Modification Instruction for:

* Improvement of frequency response of early 24 channel recorders.

** Elimination of spike noise of A80-VU recorders.

MODIFICATION

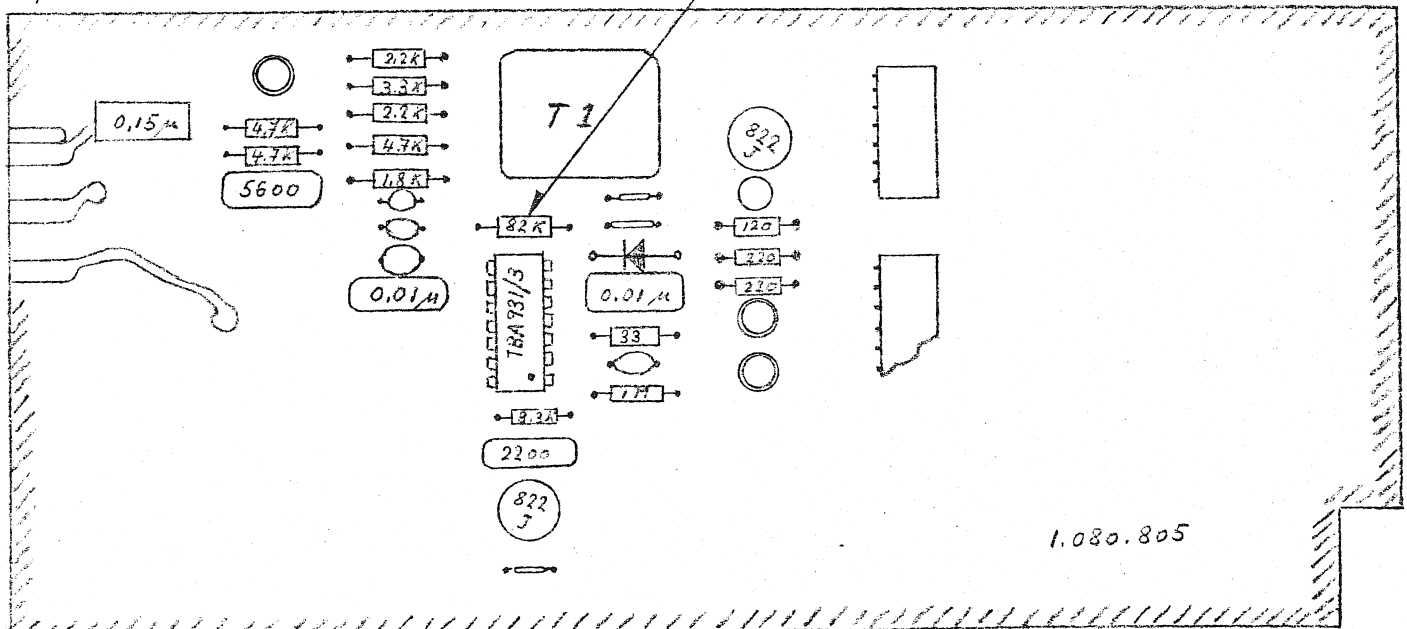
1. It has been found that the early 24 channel A80 recorders have a high frequency roll-off in the reproduce and sync channels. The cause of this short coming has been found in the too low value of the resistor across the secondary winding of the input transformer.

The 82 K.Ohm resistor near the input transformer T1 must therefore be changed to 180 K.Ohm.

* substitute 82 KΩ resistor by a 180 KΩ resistor

- * Frequency Response 24 Channel
- ** Spike Noise

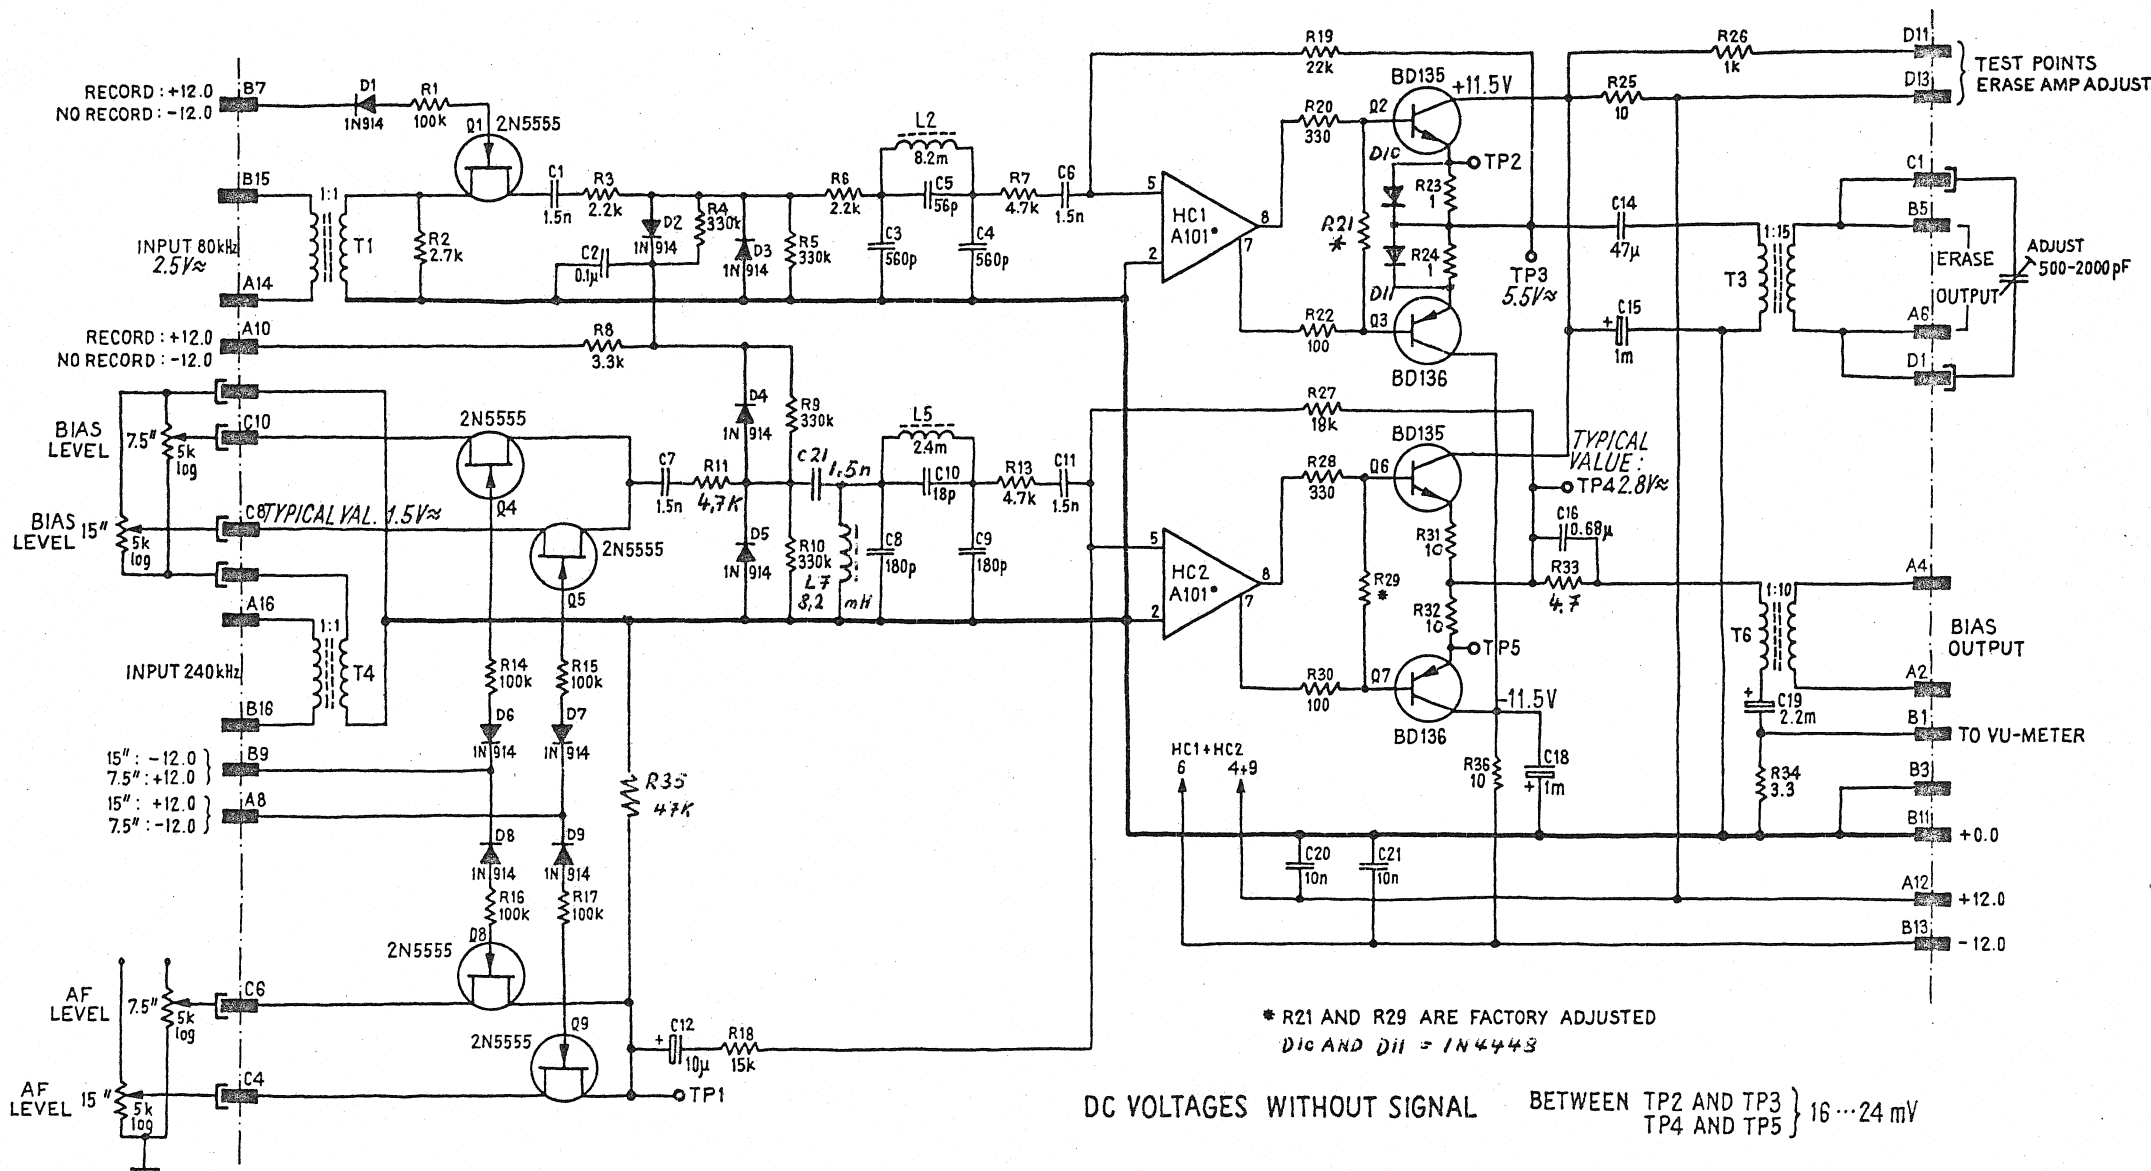
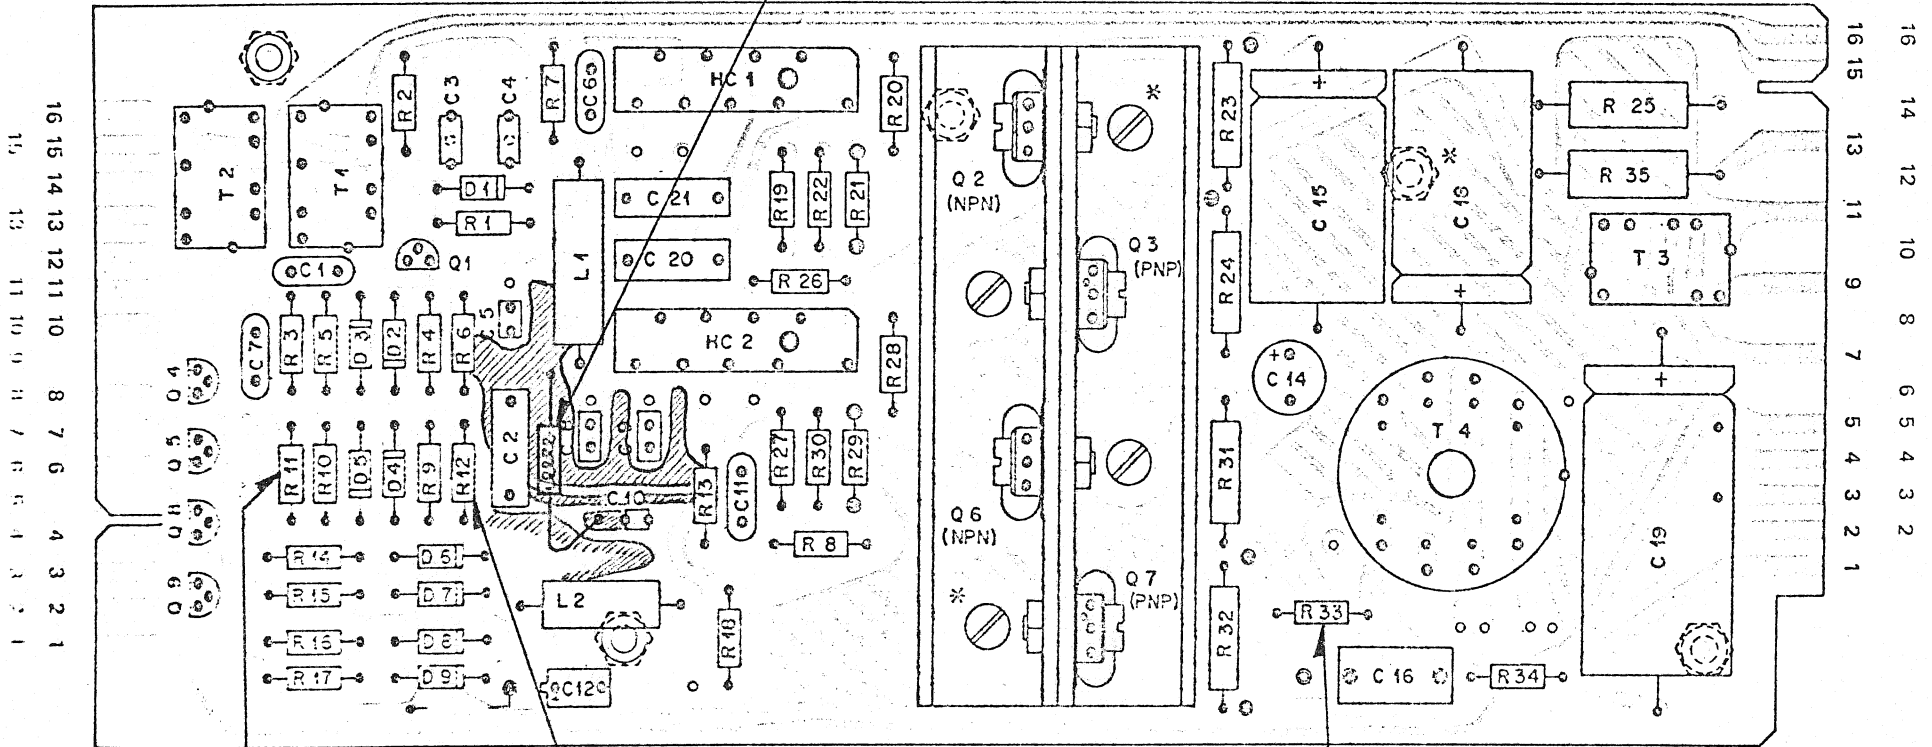
In addition it is recommended to change R33 (10 Ohm) on record driver p.c.b. 1.080.872 to 4,7 Ohm.

2. Under certain conditions it may occur that 100 Hz spikes are being recorded on the tape. These spikes may be as much as 6 dB above the tape noise.

This problem can be eliminated by the modifications on the record driver card 1.080.881 marked (**).

** Insert additional 8.2 mH choke

** substitute R11 (2.2K)
** by a 4.7K resistor

** substitute R12 (2.2K)
** by a 150pf capacitor

* substitute R33 (10Ω)
* by a 4.7Ω resistor
